COSMO Electronics Corporation

Product Change Notification

Product Name : Mini-Flat Photo Coupler

Part Numbers: KPC35X serial, KPC45X serial

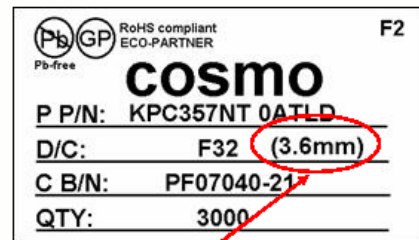
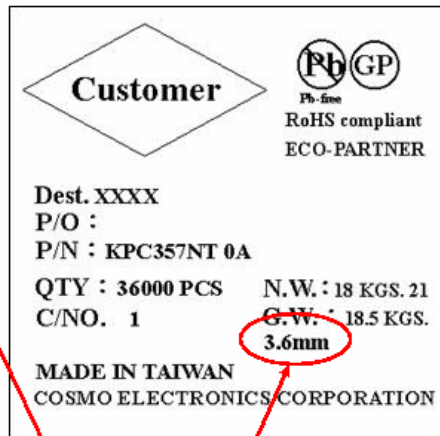
Type of Change : Package Dimensions Change

Reason for change: To meet current market requirement of smaller volume devices

According to the current demand of smaller volume devices in the market, cosmo will swap to smaller package dimension to meet customers design and remain all function specification as the same as original package.

The change of dimension is shown as below:

Original	Changed
<p style="text-align: right;">TOLERANCE : ±0.2mm</p>	<p style="text-align: right;">TOLERANCE : ±0.2mm</p>
<p>The width is 4.2 mm</p>	<p>The width is 3.6 mm</p>

Stop supply date of original dimension	2007-05-01	
Begin supply date of changed dimension	2007-02-01
